42 Honeysuckle Drive

Little National, 42 Honeysuckle Drive, Newcastle

State Significant Development (SSD-10378)

DEVELOPMENT MODIFICATIONS

5.1 Design Changes

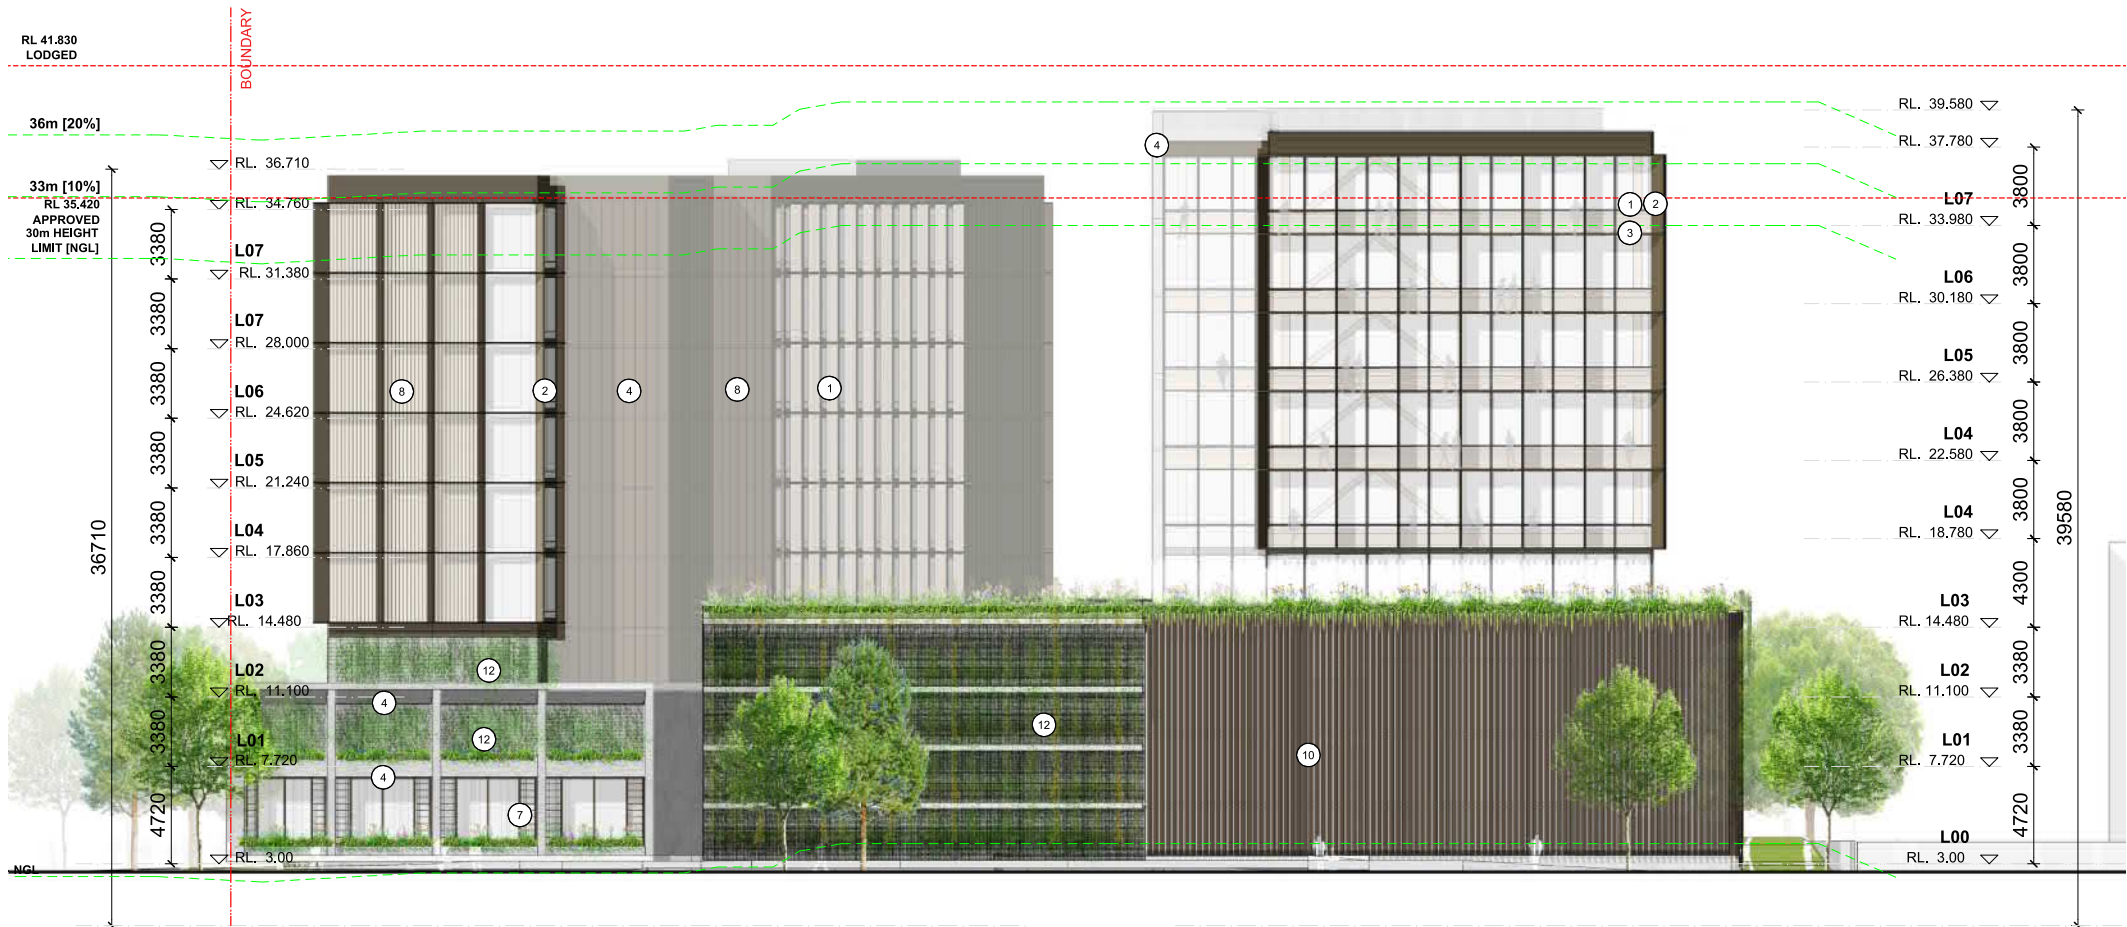
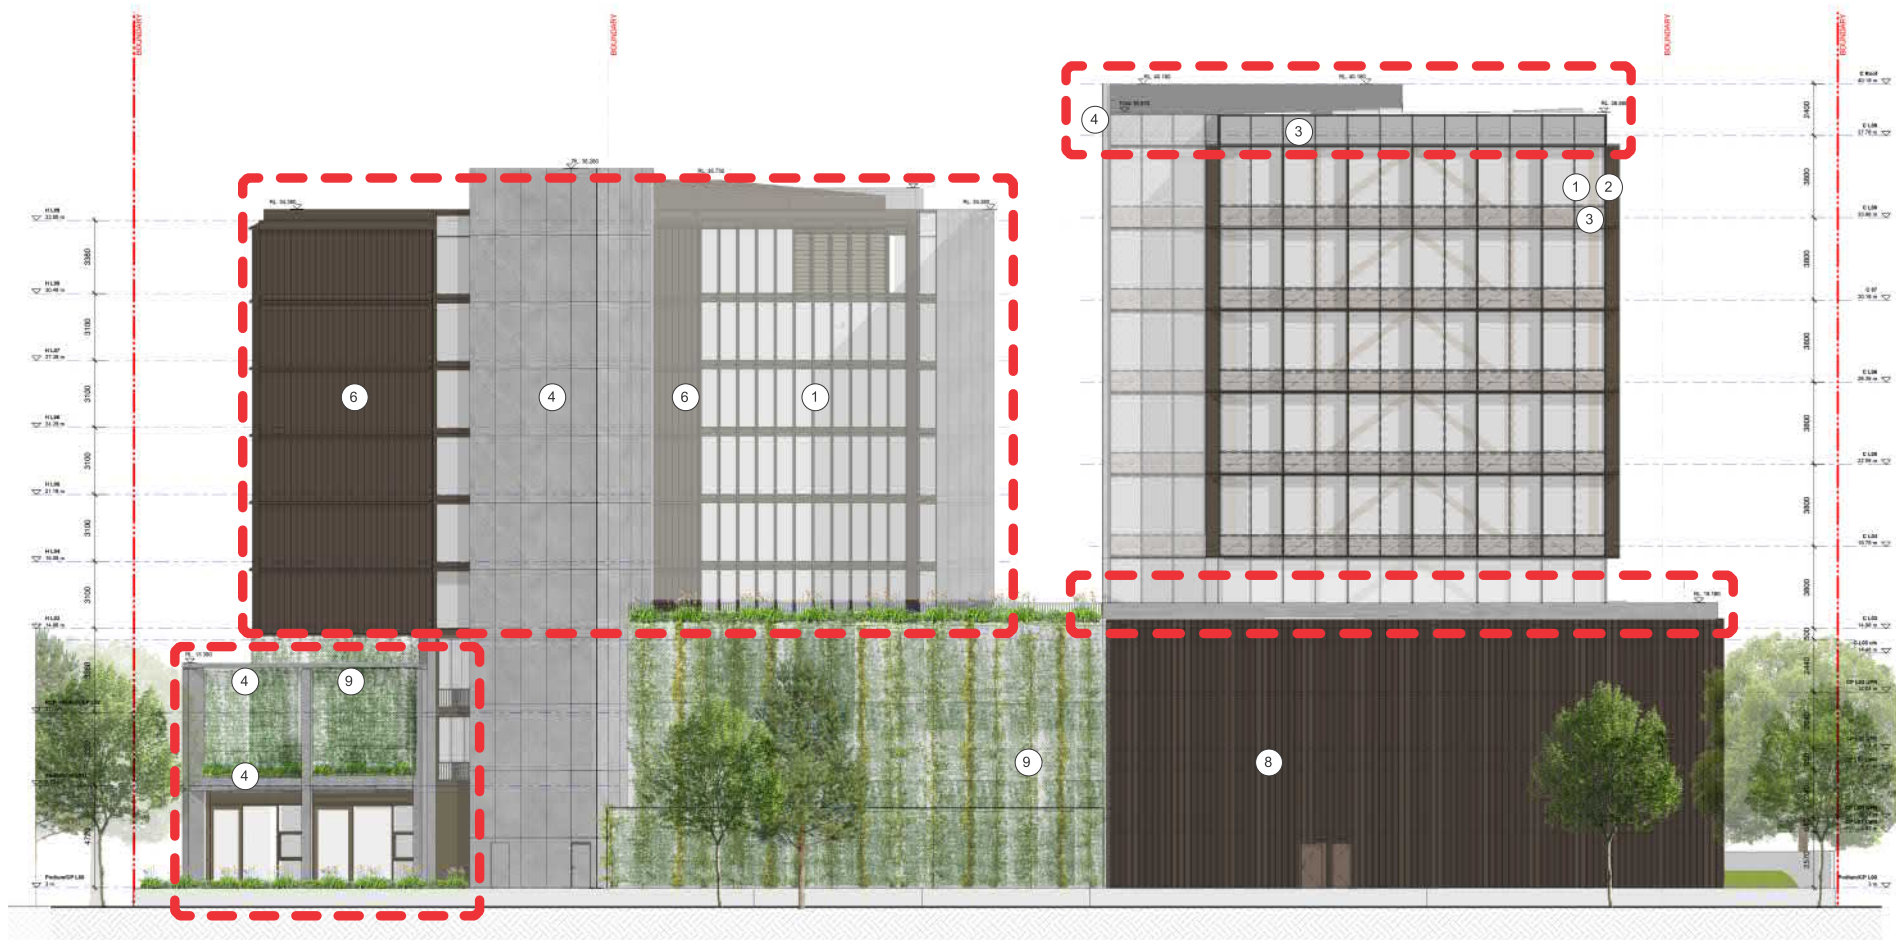
1 / Commercial tower height increased by 600mm to allow for additional plant height.
 2 / Perimeter edge planters to Level L03 omitted
 3 / Hotel slab to slab levels reduced from 3380mm down to 3100mm. This has resulted in an overall hotel building height reduction.

4 / Hotel south end of building has been reduce in length by 1 hotel room width.
 5 / Arbor structure has been pulled back at the south boundary.
 6 / With the exception of the south west hotel corner elevation the facade colours and materiality remain the same

6.1 Design Changes

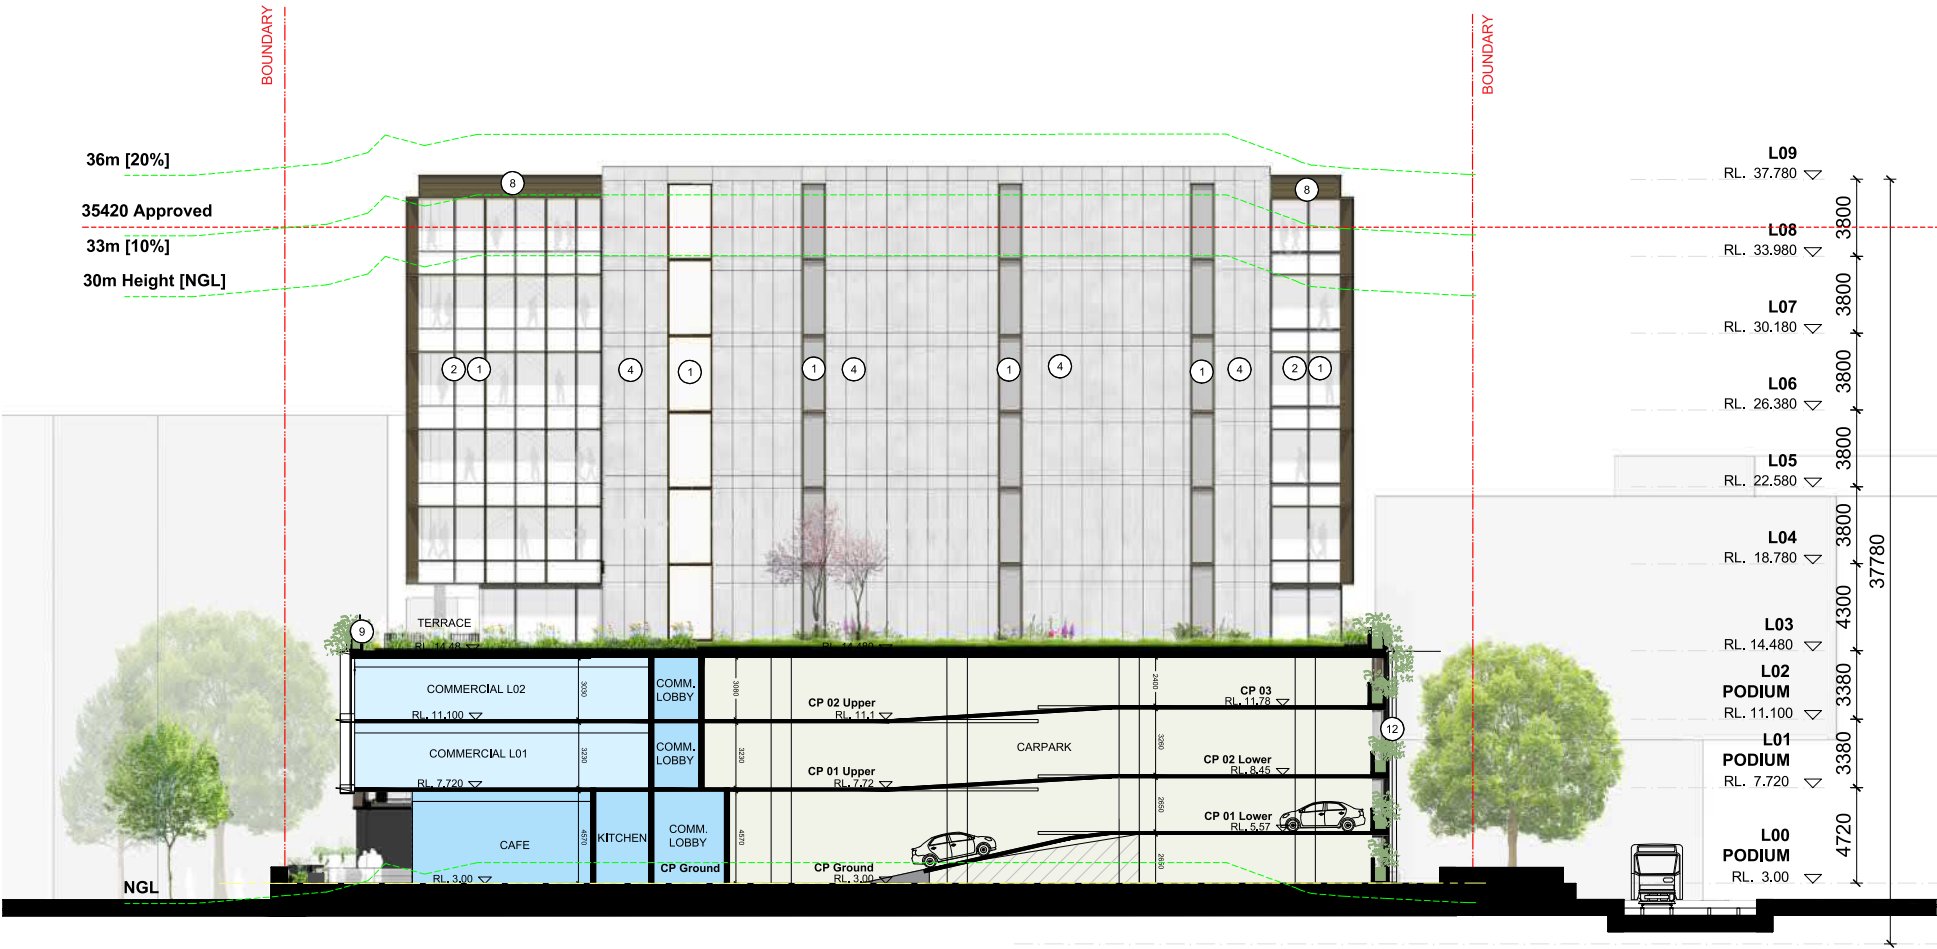
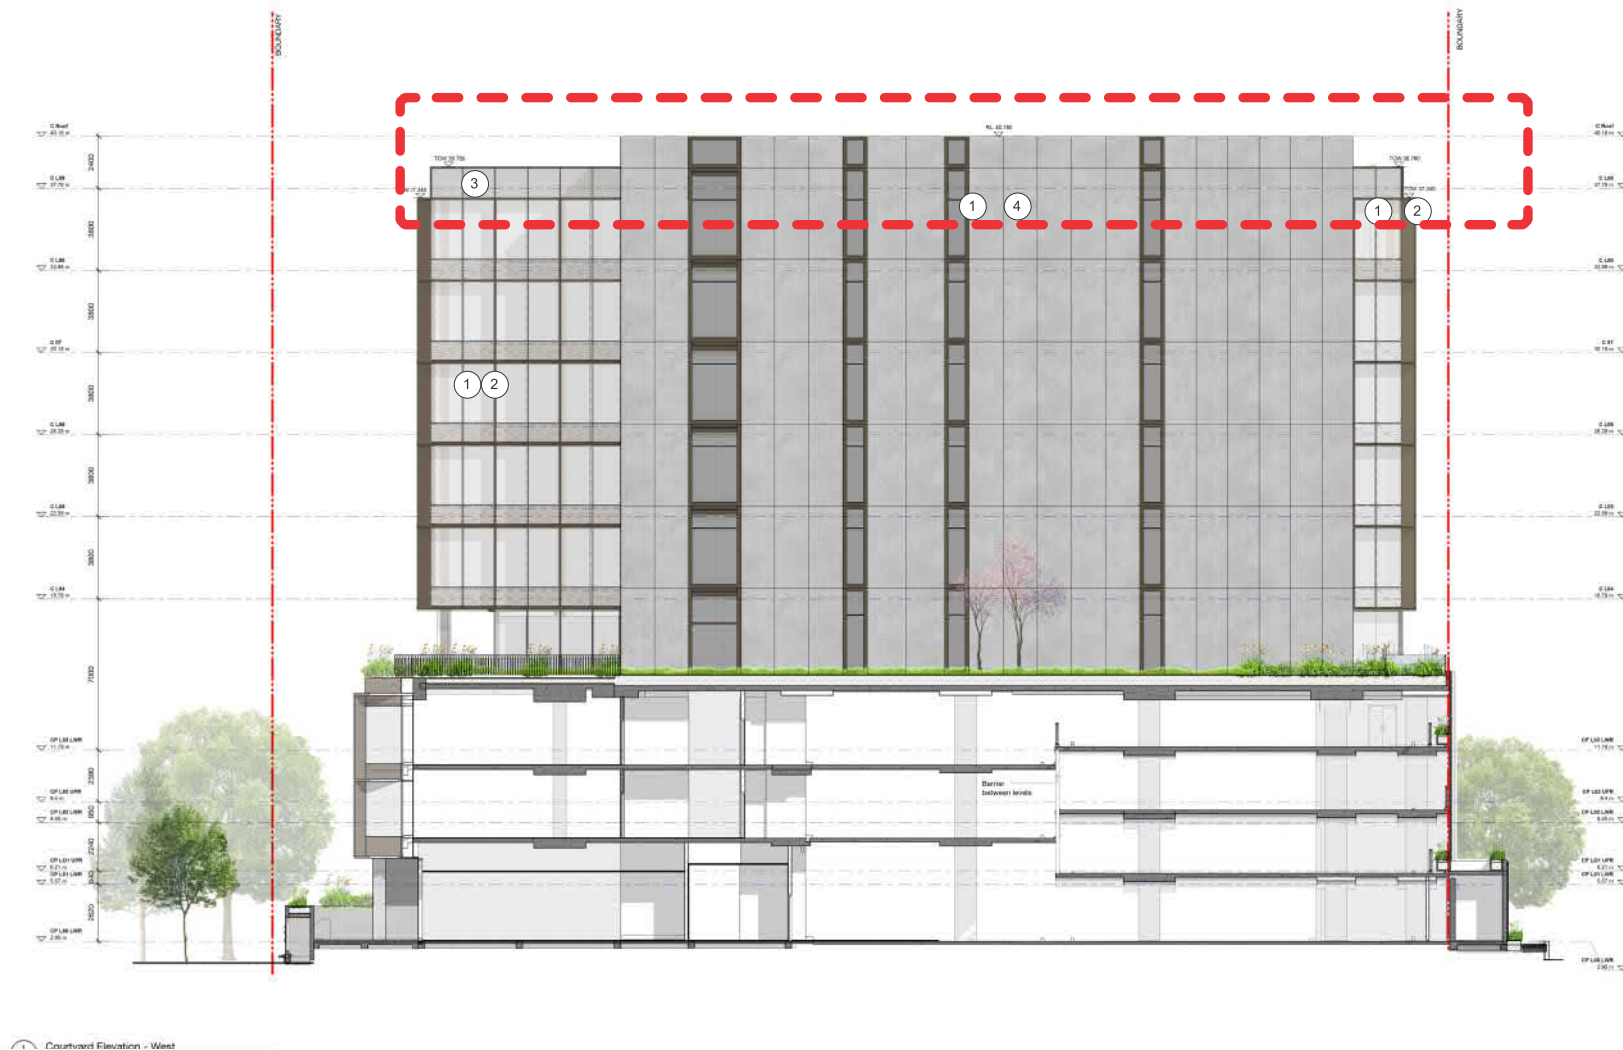
- 1 / Commercial tower height increased by 600mm to allow for additional plant height.
- 2 / Facade colours and materiality remain the same

7.1 Design Changes

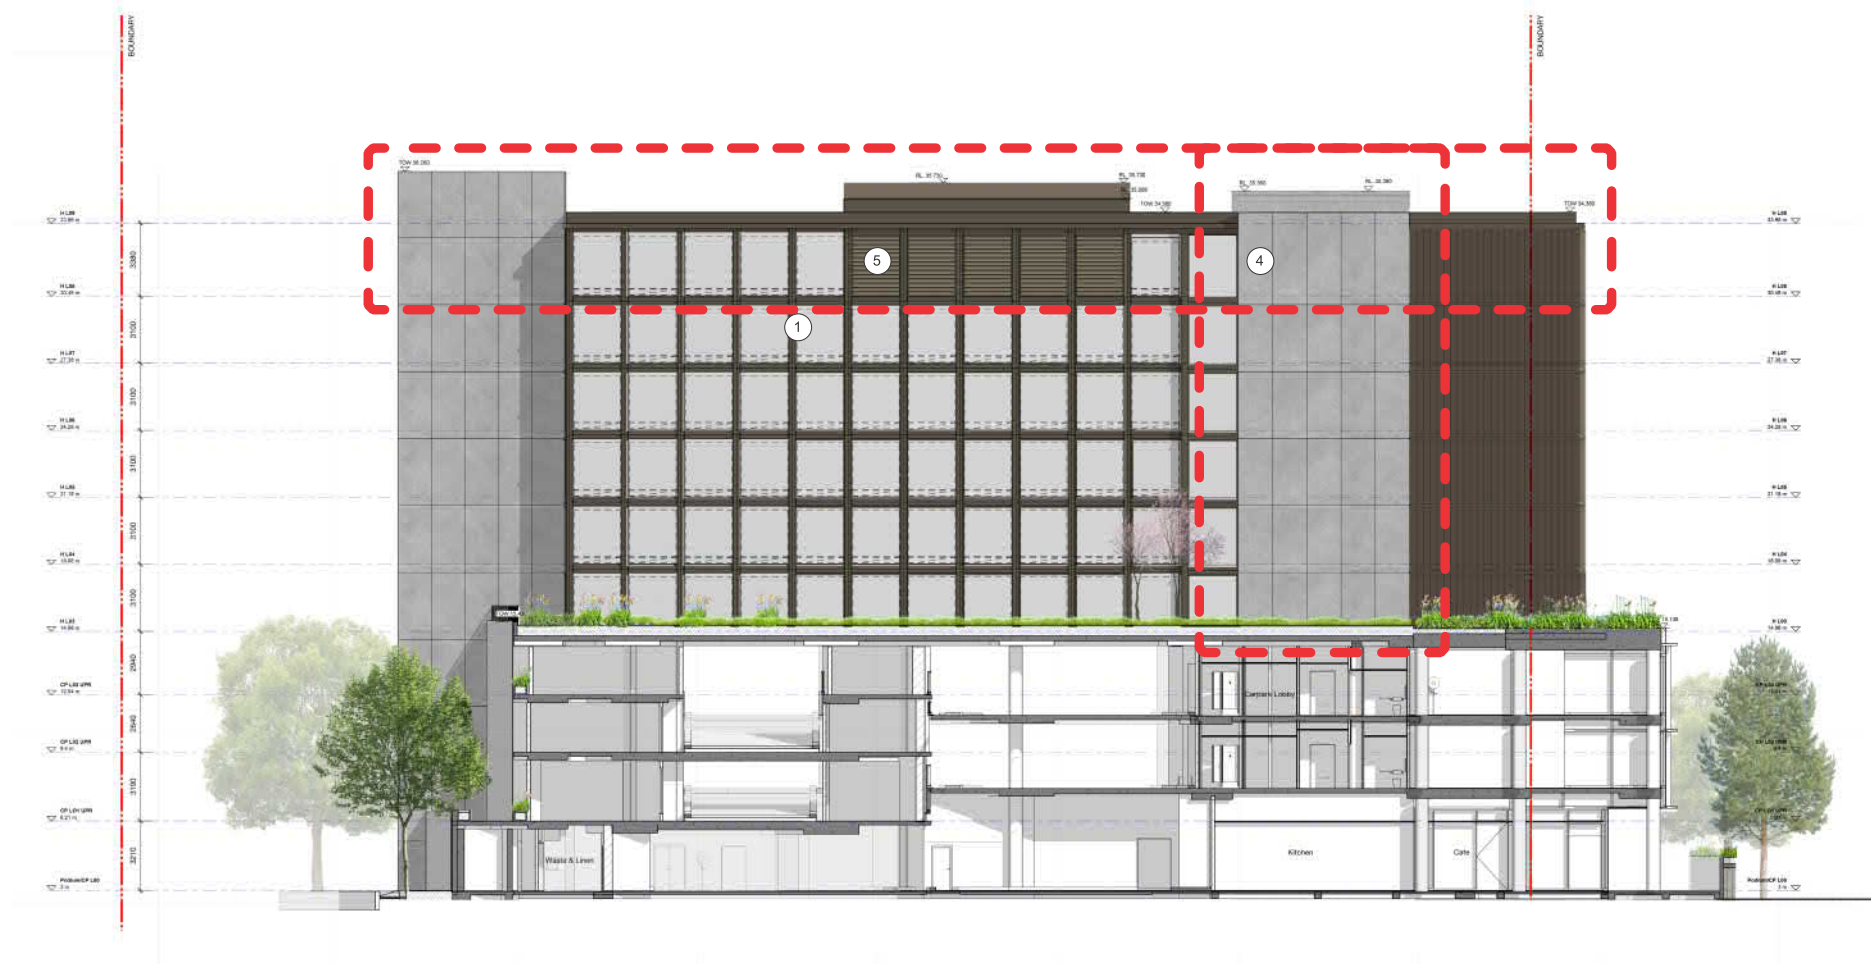
1 / Hotel slab to slab levels reduced from 3380mm down to 3100mm. This has resulted in an overall hotel building height reduction.

2 / Facade amended outside lift lobby. This is now concrete construction rather than glazing to increase privacy between the hotel and commercial tower.

3 / Facade colours and materiality remain the same
